**CITY OF LA VISTA  
PLANNING DIVISION**

**RECOMMENDATION REPORT**

CASE NUMBER: 2015-CUP-02  
2015-PUD-04

RE: Comfort Suites Design Review #1

ESP1.1  
\*15047

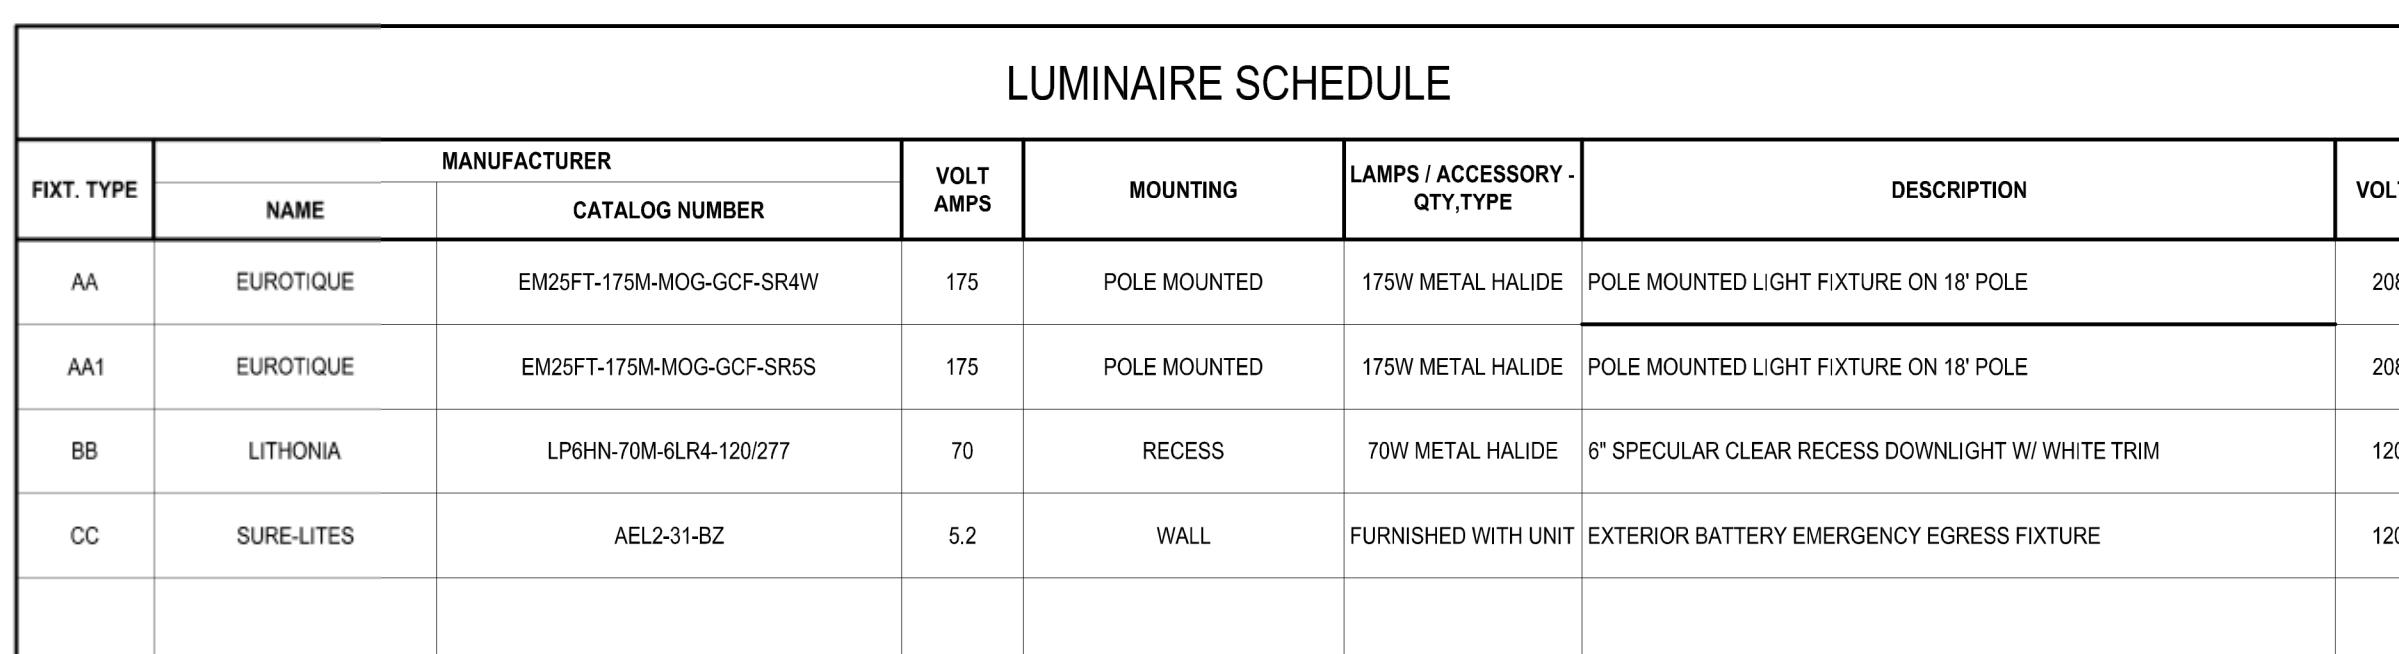
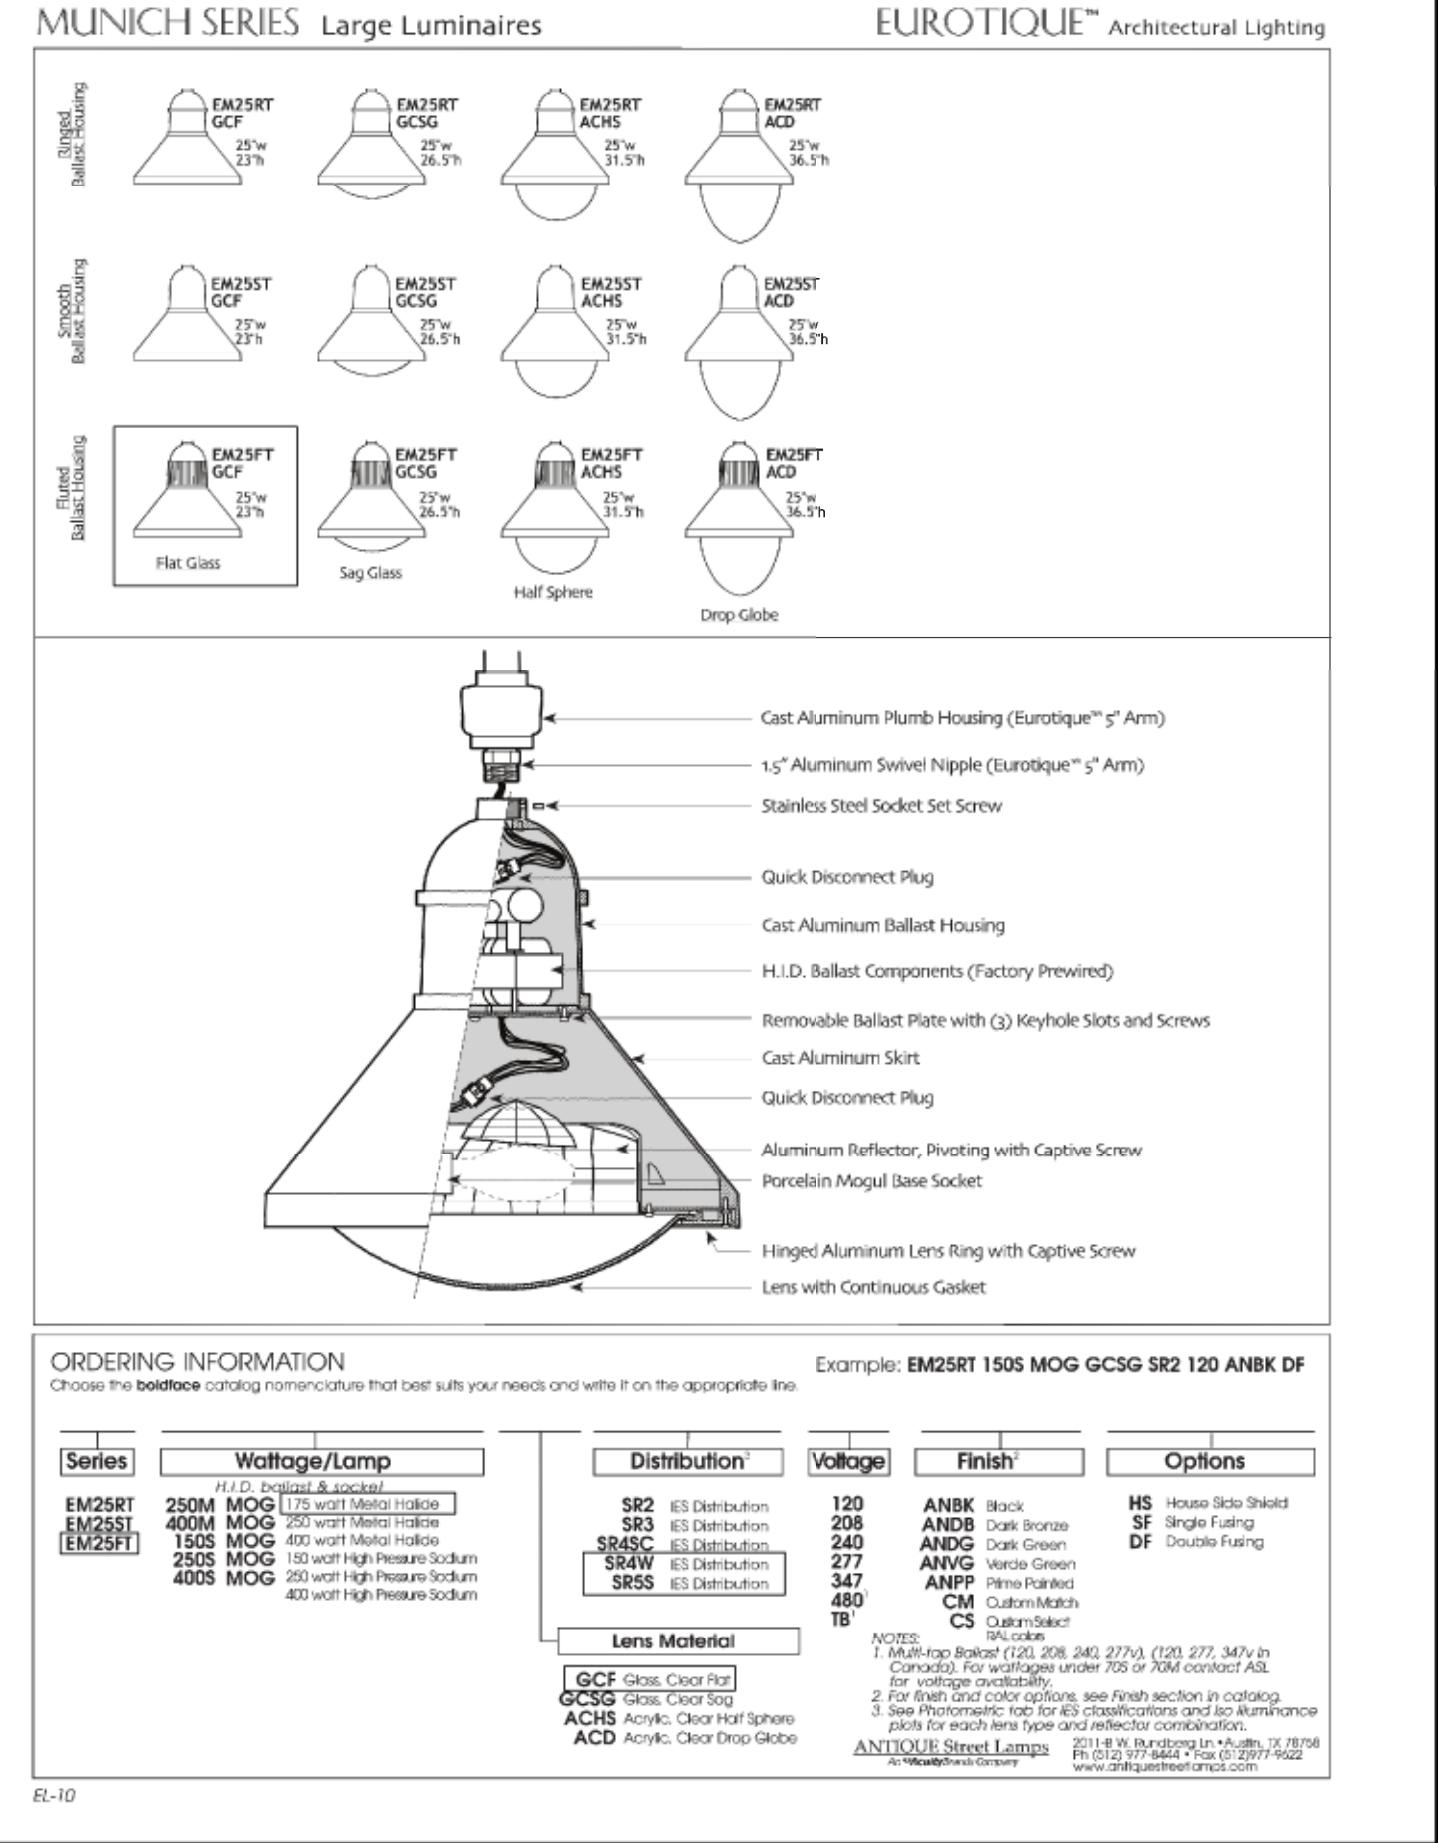
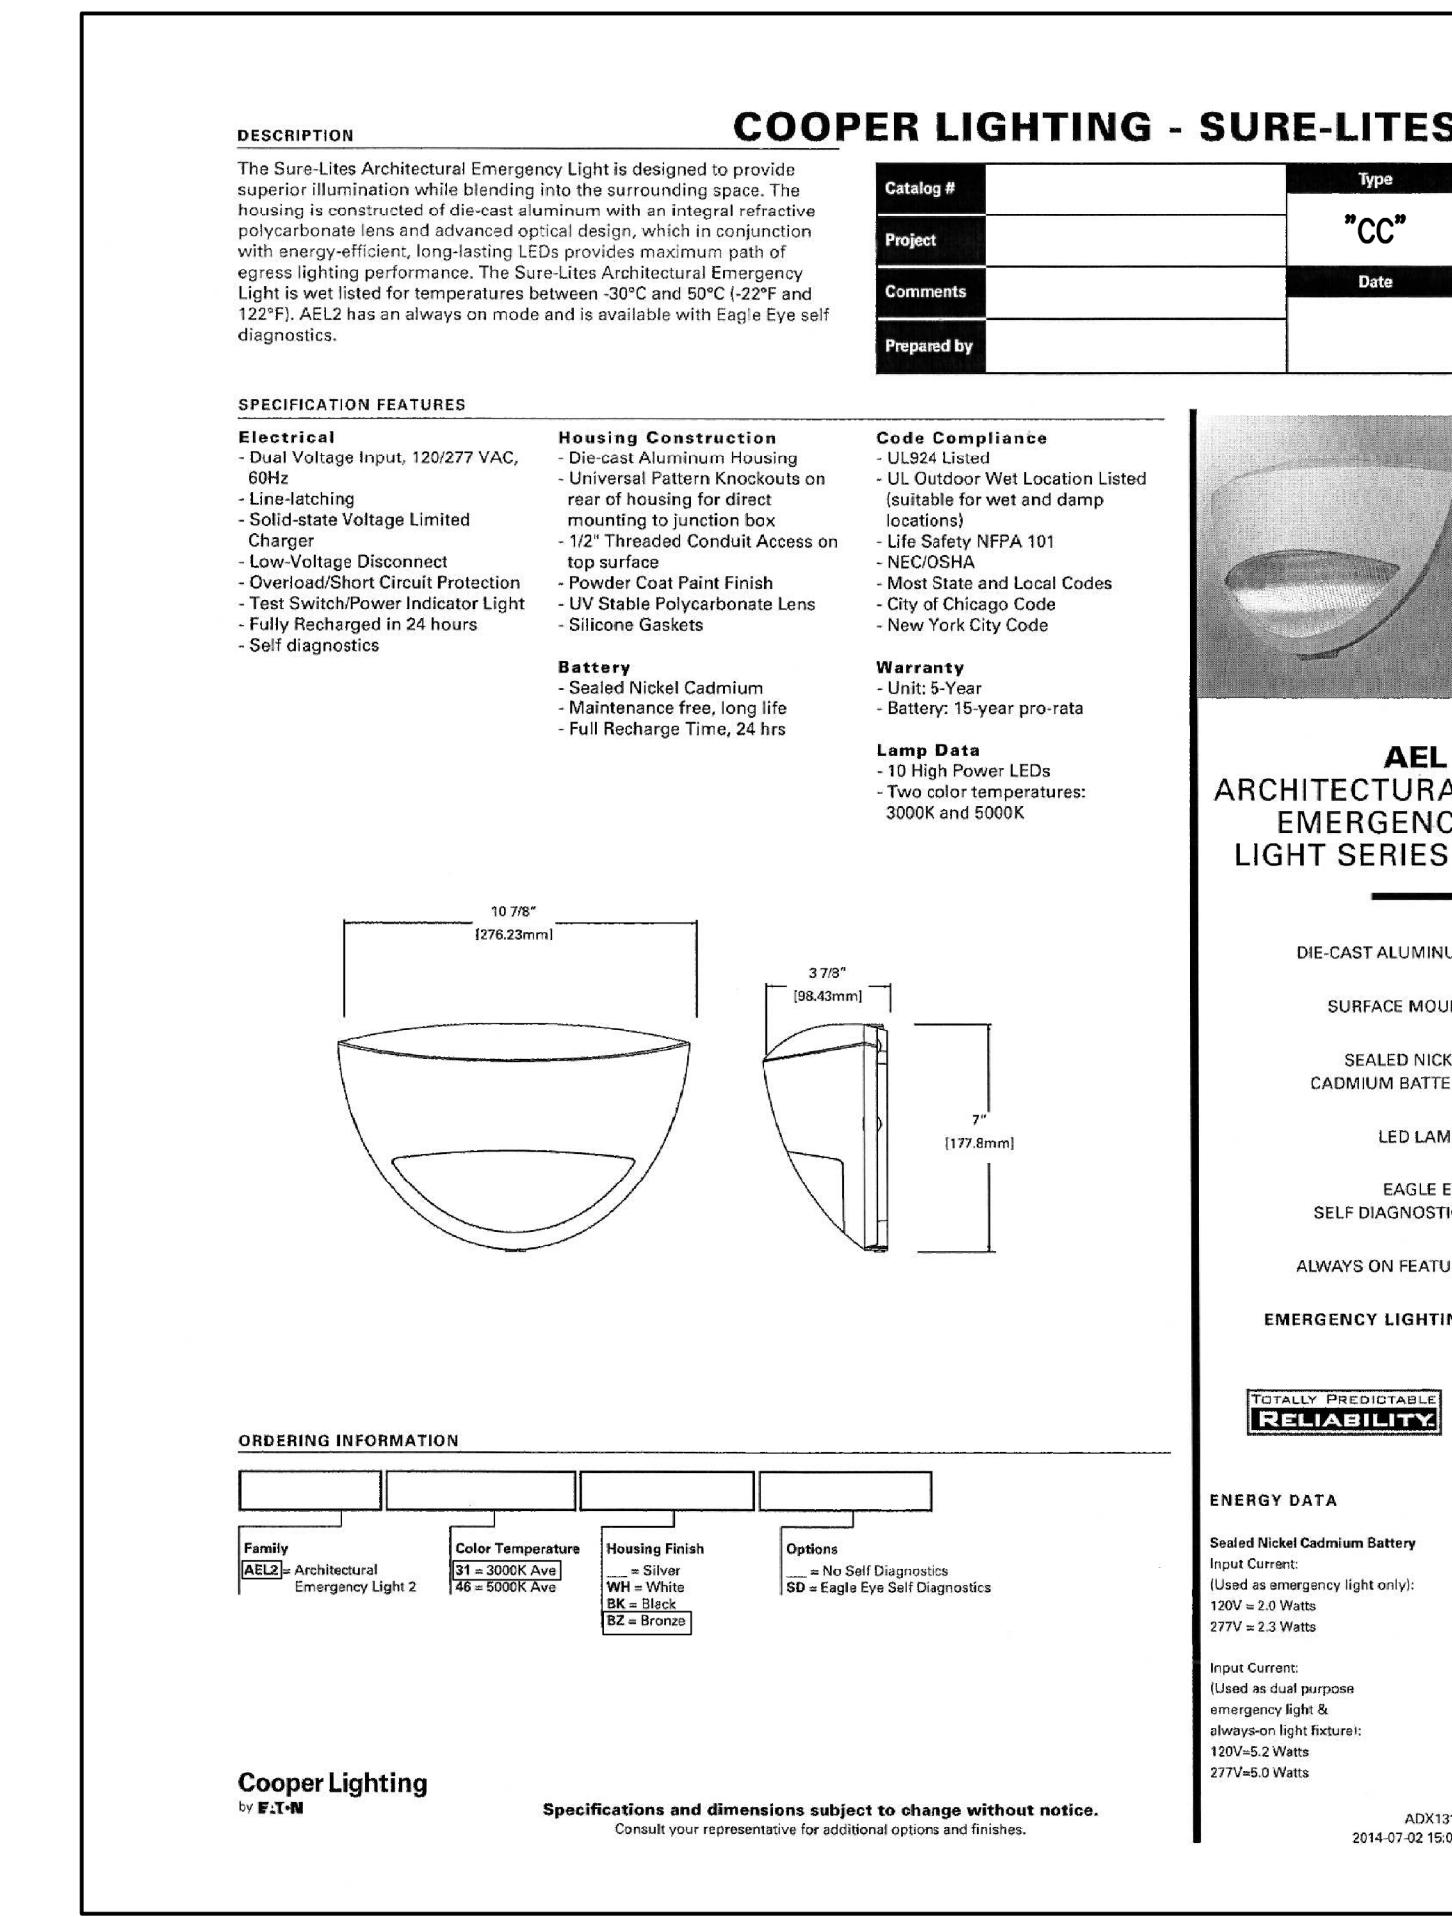
1. Parking lot pole lights "AA & AA1" do not comply. Refer again to Appendix H. and I. for site lighting requirements.
2. Wall pack fixture "CC" is generally acceptable, but needs to be re-specified with a lens configuration that provides full cut off so the light source is not visible. Locations for this fixture need to be shown on the exterior elevations and rendering.
